**TOWN OF PORTOLA VALLEY
ARCHITECTURAL AND SITE CONTROL COMMISSION (ASCC)
Monday, October 26, 2015
7:00 PM – Regular ASCC Meeting
Historic Schoolhouse
765 Portola Road, Portola Valley, CA 94028**

a. Architectural Review for Fencing, File #: 25-2015, 4 Oak Forest Court, Quinn Residence (Staff: C. Borck)

c. Architectural Review for Replacement Landscaping, exterior lighting, koi pond, decking, stone paths, File #21-2015, 30 Zapata Way, Baskett Residence (Staff: C. Richardson)

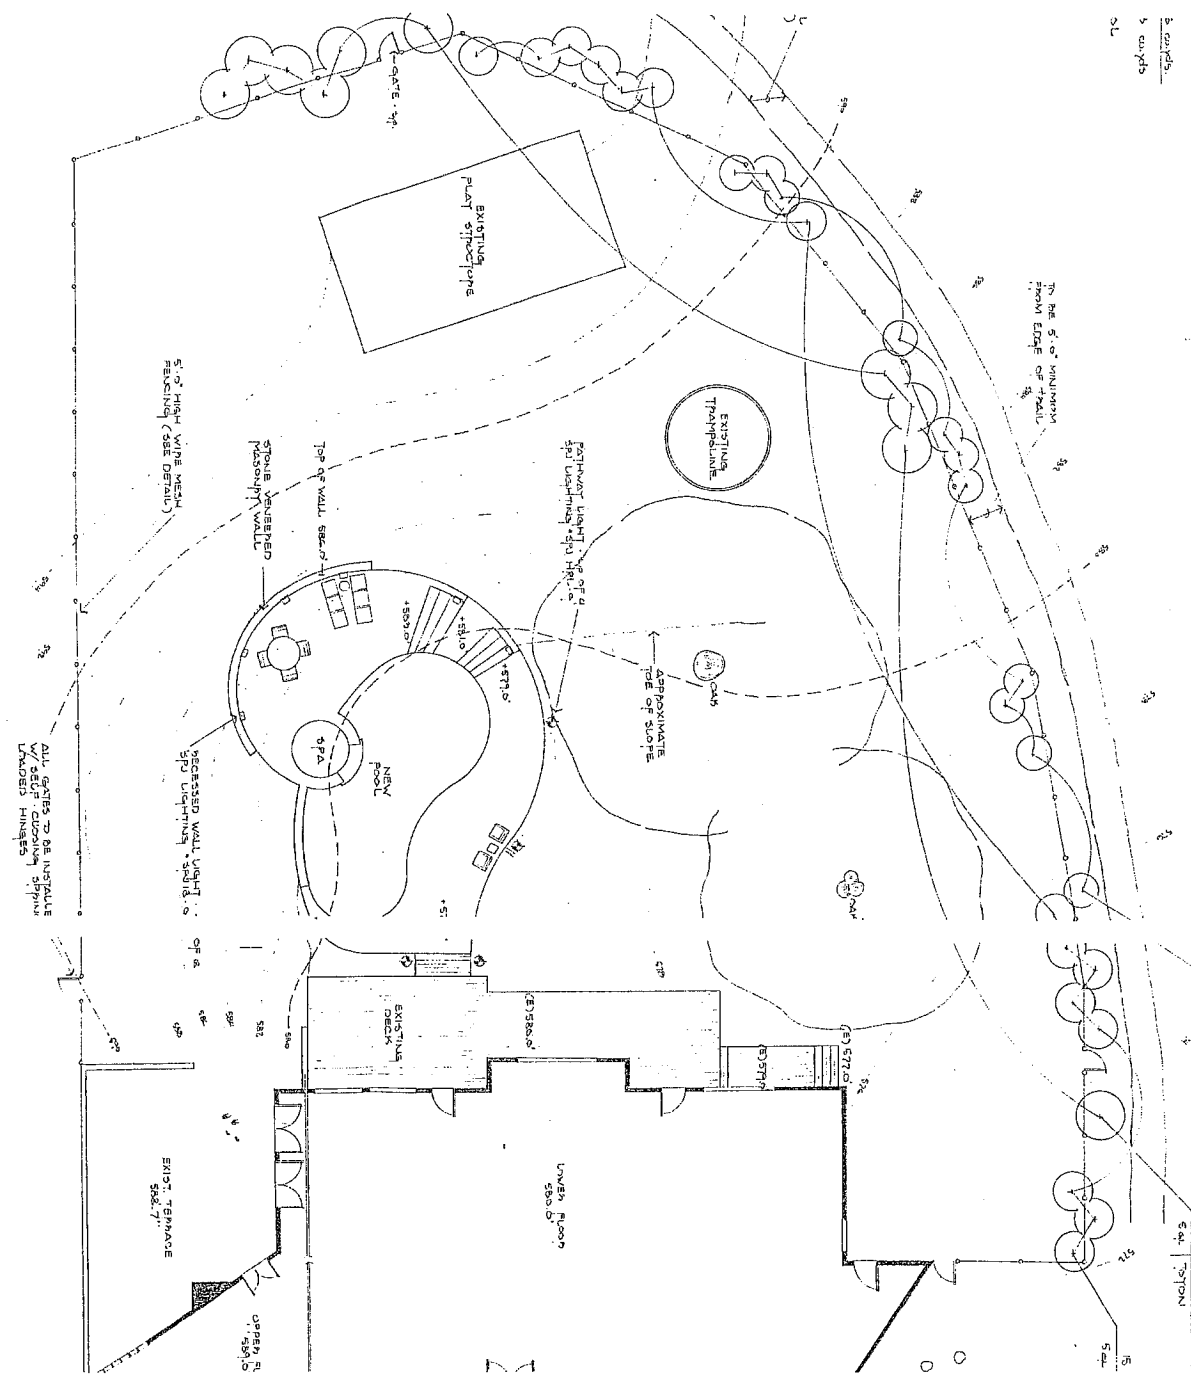
Our property is also located within a Planned Unit Development, Portola Glen Estates PUD approved 4/13/1988. Within the PUD, there is a statement that "No fences permitted on property lines". There are no specifics on the intent of this clause but we respect the interpretation that you have provided; that being that the intent was to not use fences to define property lines. Our interpretation is that this also may have been intended to avoid disputes between the property owners within PGE where 2 properties are adjacent. In the case of our fence proposal, we are looking to provide containment for our dog and security/privacy between our property and the Black Oak trail. The fence will run on/within our property and will only be adjacent to the open space parcel (Lot A). We have reviewed the fence proposal with the property owners in PGE, and all households have approved the plans. They are all very supportive of installing a fence for privacy and security concerns. In order to comply as much as possible with the "no fences on property lines" clause, we have taken your advice and have the fence lines "meandering" away from our property lines wherever possible. Our challenge and limitations for meandering are that we need to keep the fence away from the large oak clusters and redwood trees that are close to our property lines, and the fact that the trail comes very close to our property lines (little space between the trail in Lot A and the large oaks and redwoods near our property lines). (See Fence Plan).

The reasons for our need for a fence are many. I will try to be brief and list them.

- Security: We have increasingly had people, dogs and wild animals (coyotes, bobcat, boar, and mountain lions) in our back property. 2 years ago we had 3 deer kills and a boar kill in our back area. We regularly now have people cutting through our property to take our driveway out to Los Trancos road from the Black Oak trail. We have had prowlers come onto our deck 2 times in the past year and set off security lights on our deck. Our neighbors within PGE have been burglarized twice in the past year and our back area is completely screened to is very susceptible to burglars entering our property from the trail to enter our house from the back.

Tree Planting Plan

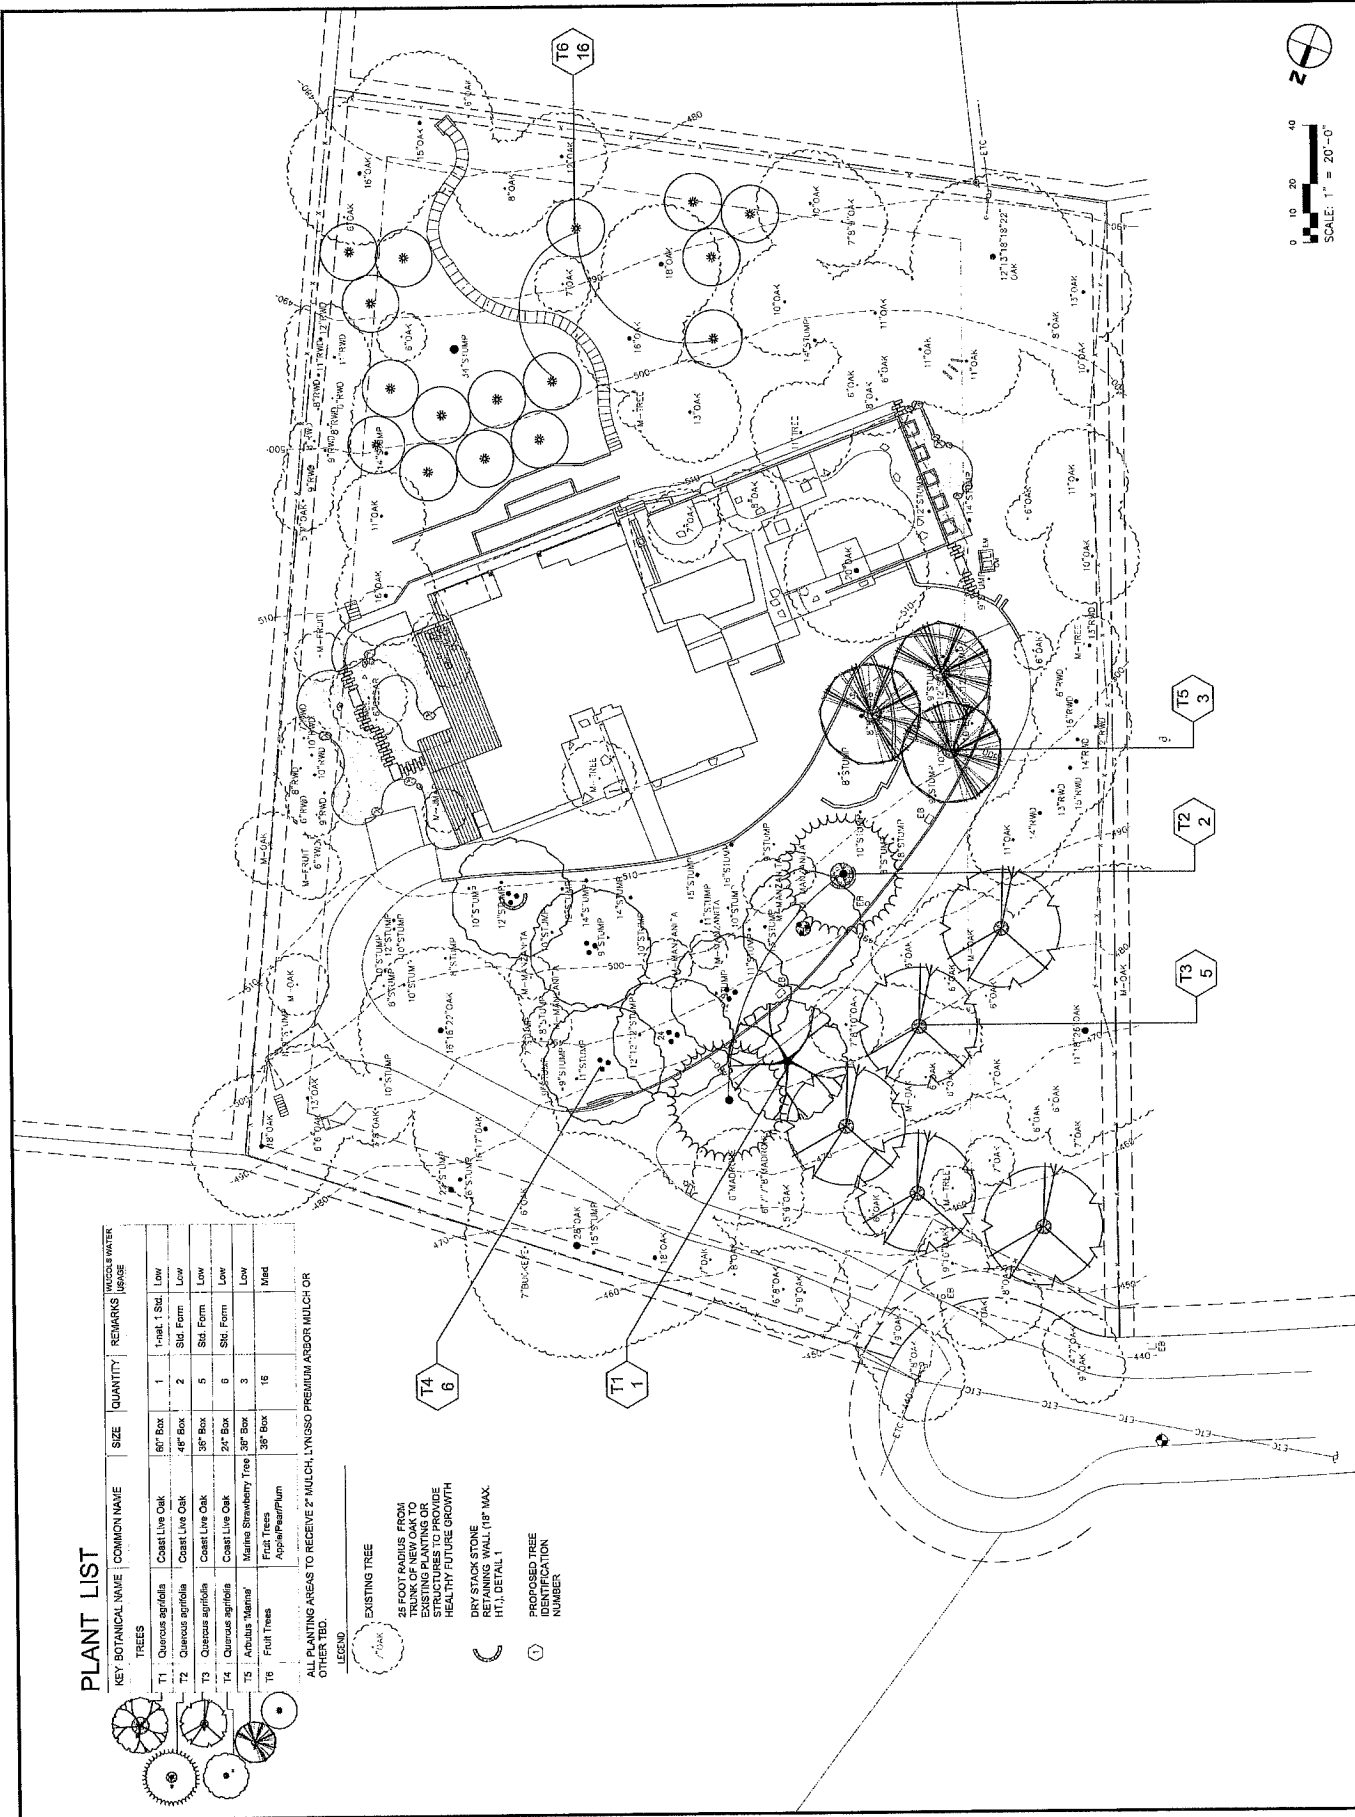
The conservation committee reviewed this project on September 25, 2015 and commented that the size and number of the replacement Coast Live Oak is excessive (Attachment #8). The Committee has a preference for 24" or 36" box size instead of 48" or 60" size. They also suggest the planting of 2 coast Live Oak trees in the open space below the driveway and removal of the invasive Acacia tree. The Committee also suggests the steep upper hillside should maintain lower bushes rather than trees and to utilize the cut Toyon that should grow back. Introduction of other shrubs such as Coffeeberry, Holly Leaf Cherry and more Toyon would cause less soil disruption than the planting of new trees. After discussion of these suggested modifications, the ASCC may wish to impose conditions to reduce the number and size of the required tree replacement and removal of the invasive Acacia tree.

Our assessment is that the size and number of the replacement CLO is too high; densely planted trees do not grow well. In our experience CLO trees transplant successfully if they are smaller. The smaller transplants will grow faster and

provide the desired screening sooner. Our preference is for 24” or 36” box size, not 48” or 60” size. We suggest the planting of just 2 CLO trees in the open space below the driveway downhill from the upright hose bib. No trees should be planted near the existing Madrone trees, and the saplings growing near the larger of the Madrones should be removed to protect this specimen tree. Planting CLO in this location will help to screen the house from the property on the opposite hill side. The nearby invasive Acacia tree should also be removed.

The slope directly in front of the house where the CLO planting is proposed has some large Manzanitas; it is steep, in full sun and the ground partially bare. To achieve screening on the upper hillside, lower bushes are needed rather than trees. A number of Toyon stumps have started sprouting; their growth will provide some immediate screening. If needed, shrubs such as Coffeeberry, Holly Leaf Cherry and more Toyon would cause less soil disruption and could be more successful than digging in 14 large CLO. The shrubs will stay within the sight line of the lower neighbor without blocking the owners’ view. The planting of a native ground cover such as a low growing Manzanita on the hillside is recommended for optimal erosion control. All new plantings will need drip irrigation.

We agree with the placement and size of the 3 proposed Arbutus “Marina”. If the owner would like to remove some of the Redwood tree hedging along the uphill lot line the Conservation Committee would be supportive, since this property is not an appropriate site for Redwoods to have been planted.

This letter is to address the comments and/or recommendations from the Westridge HOA committee. The recommended 60-inch boxed trees to be planted on this slope in a vertical position will require a significant cut on the uphill side and eventually the root crowns will be covered.

Planting a tree this way will essentially put the uphill roots significantly below grade and reduce root establishment. This will take a much longer time as compared to 24-, 36-, or 48-inch boxed trees. In 5 years these smaller trees will be about the same sizes as the 60-inch boxed trees.

A 36-inch boxed tree will actually out perform a 48-inch boxed tree within a 5-year span. Therefore, I would recommend no larger than 36-inch boxed specimens to replace the removed trees. I think these will be better and disturb the soil a lot less.
